MONITORING YEAR 2 ANNUAL REPORT FINAL

MCLENNY ACRES MITIGATION SITE

DMS Project No. 100038
NCDEQ Contract No. 7423
DWR Project No. 2018-0197
USACE Action ID No. 2018-02042

Subject: McClenny Acres Mitigation Site – Monitoring Year 2 Report
Neuse River Basin – HUC 03020201
Wayne County
DMS Project ID No. 100038
Contract # 7423

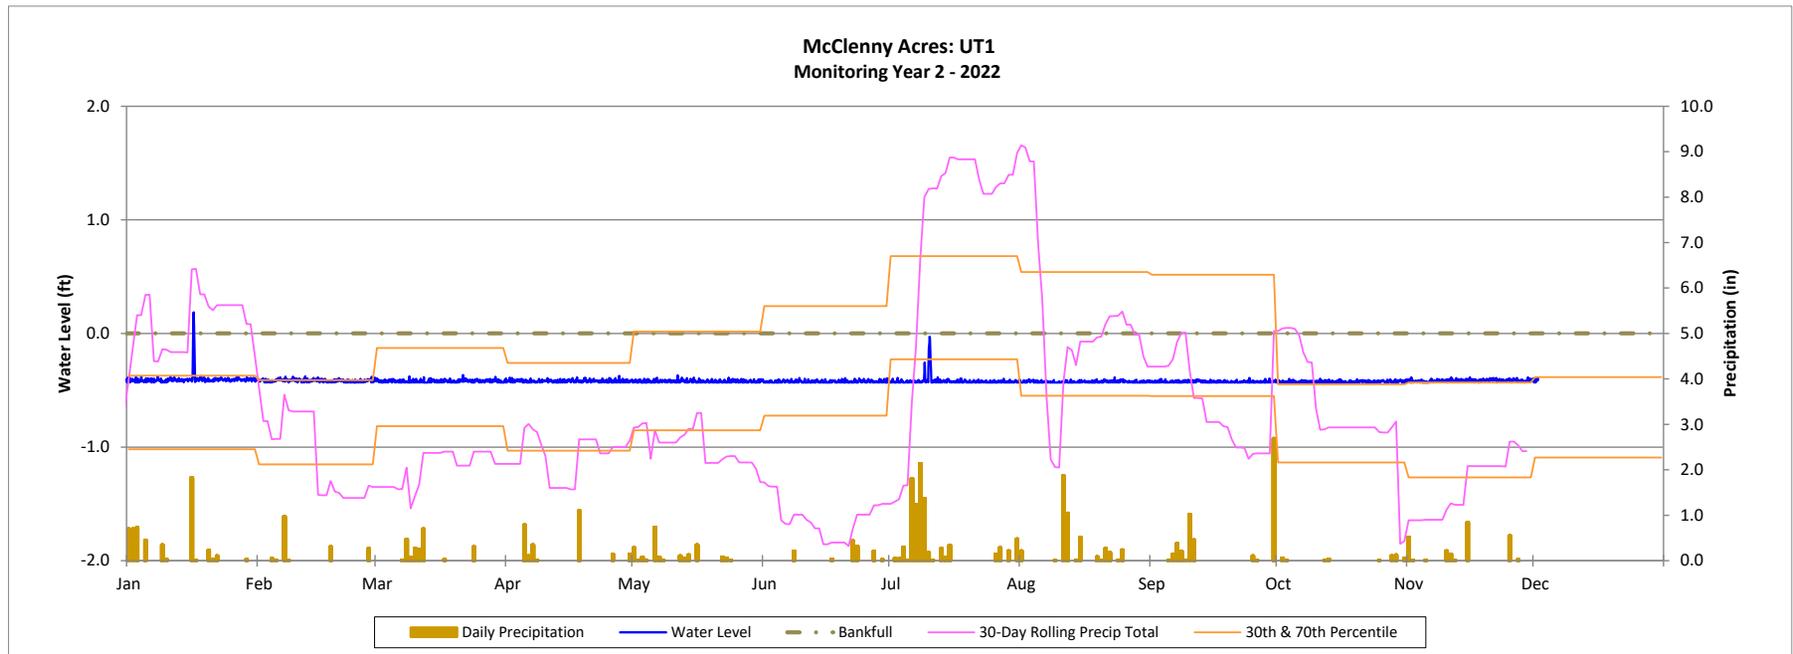
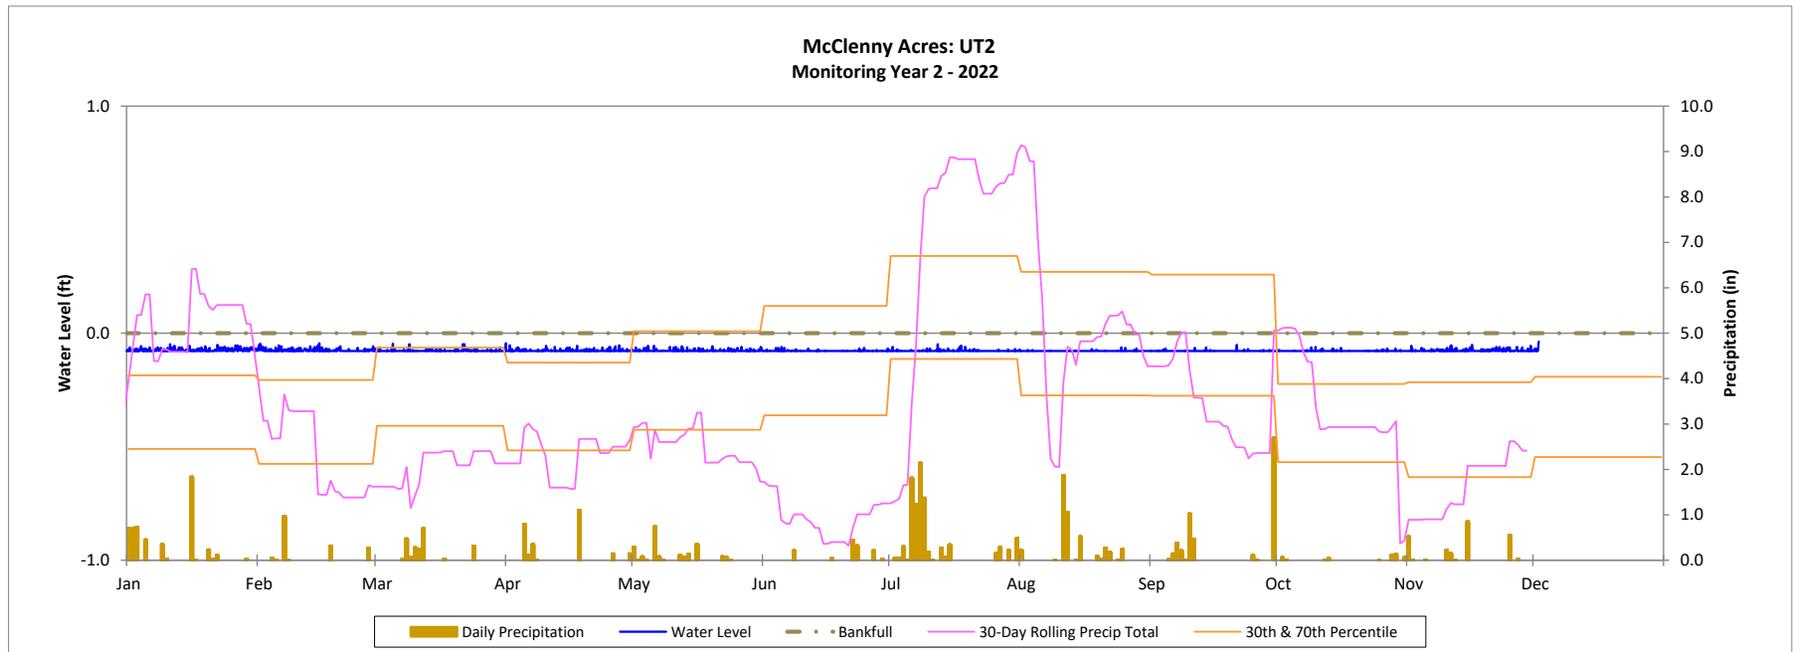
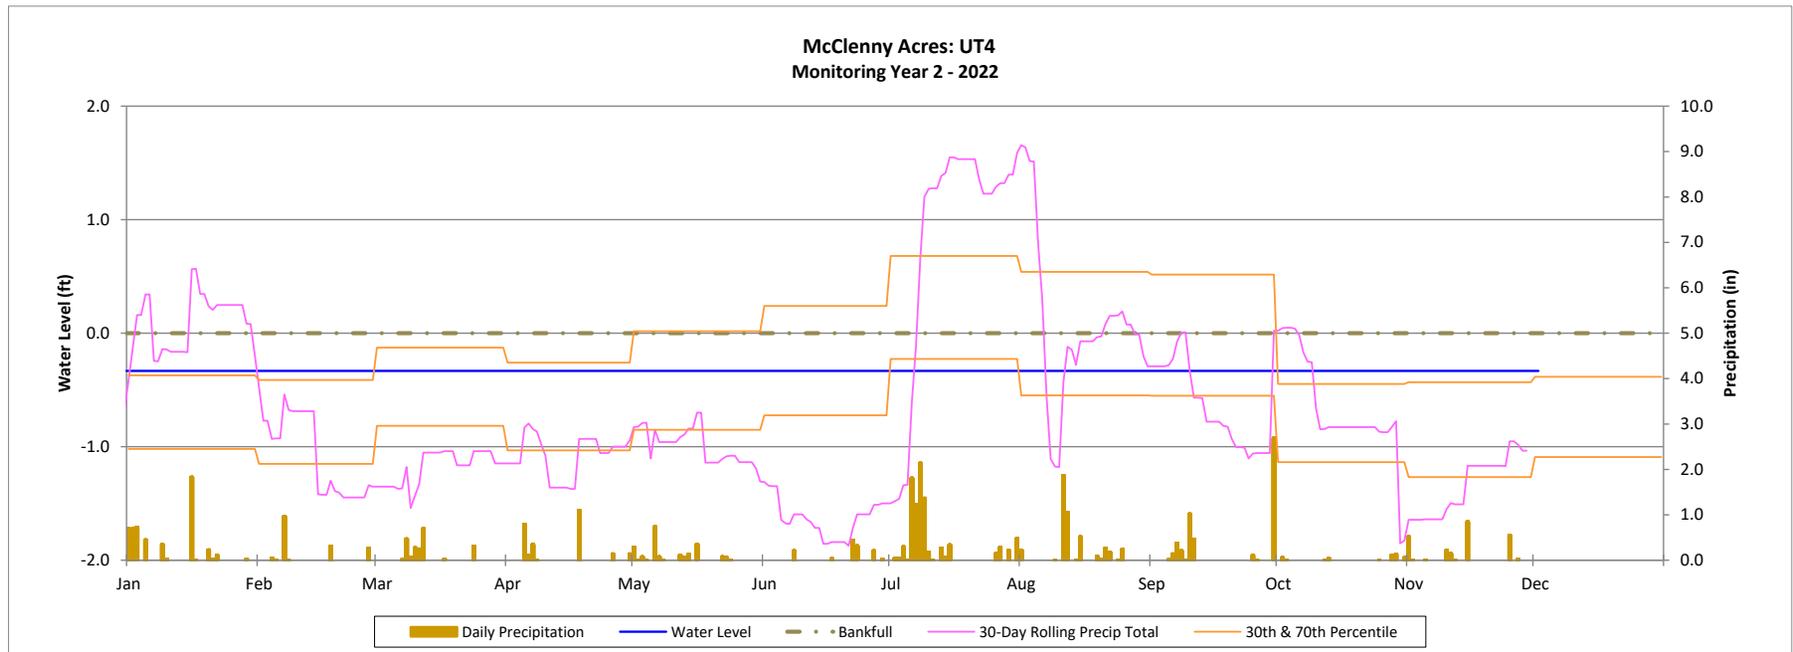
2. No hydrograph was included in Appendix D for UT3.

Response: UT3 is equipped with an in-stream flow gauge which measures stream flow and bankfull events while UT1, UT2, and UT4 are equipped with crest gauges mounted on the stream bank which only measure high flow events. The UT3 Recorded In-Stream Flow Events Plot was included in Appendix D following the Recorded Bankfull Events Plots for UT1, UT2, and UT4. The two types of gauges are measuring different criteria parameters so they were separated in the appendix instead of providing hydrographs in sequence of tributary number.

3. The hydrograph for UT4 shows no variability in water level in response to rain events. Is this accurate?

Response: This data is correct, but further explanation of how crest gauges are installed may facilitate interpretation. UT4 is equipped with a crest gauge mounted on the stream bank at an elevation above typical baseflow but below the bankfull elevation. During MY2, the stream flow elevation did not reach the elevation of the pressure transducer. For crest gauges installed as this one, plots are titled "Recorded Bankfull Events Plot." The flat line portions of recorded data on these plots are arbitrary and are the result of stream flow being below the elevation of the pressure transducer. The relevant and meaningful data are the spikes which are indicative of above baseflow conditions.
